# Access Compliance Report

## Public Rights-of-Way

| Intersection ID: 24557 | Main Street: PARK_CROSSING_DR | Cross Street: WARWICK_CR | Location: SE           |
| ADA ID: 12BE8DFD1EE5   | Ramp Type: PerpDiag           | Initial Pass/Fail: Fail  | Overall Compliance: No |

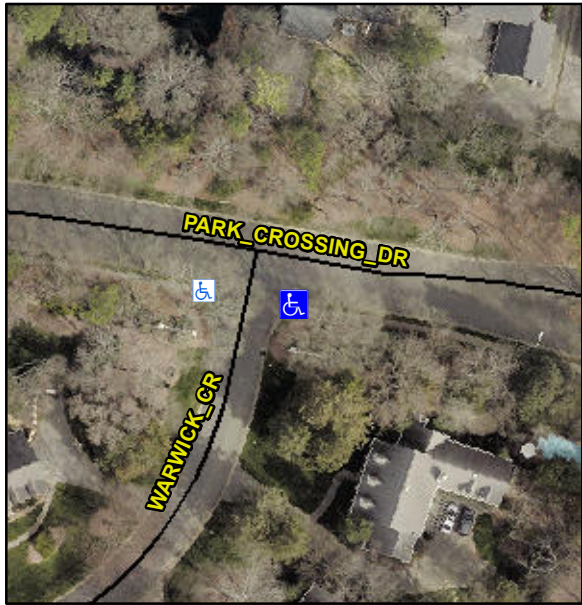
| Codes/Mitigation Info/Possible Solution  |  |                    | Field Measurements/Component Compliance |                       |      |            |                             |      |
|--|--|--------------------|---|-----------------------|------|------------|-----------------------------|------|
|  | Remove & Replace Curb Ramp With Two New Directional Ramps or Equivalent. |                    | N/A                                     | Ramp Length (in)      | 33.0 | No         | Ramp Slope (%)              | 8.5  |
|  |  |                    | Yes                                     | Ramp Width (in)       | 48.0 | No         | Ramp XSlope (%)             | 2.3  |
| PROW/ADA:  |  | R304.2.2, R304.5.3 | N/A                                     | Shared Landing?       | N/A  |            |                             |      |
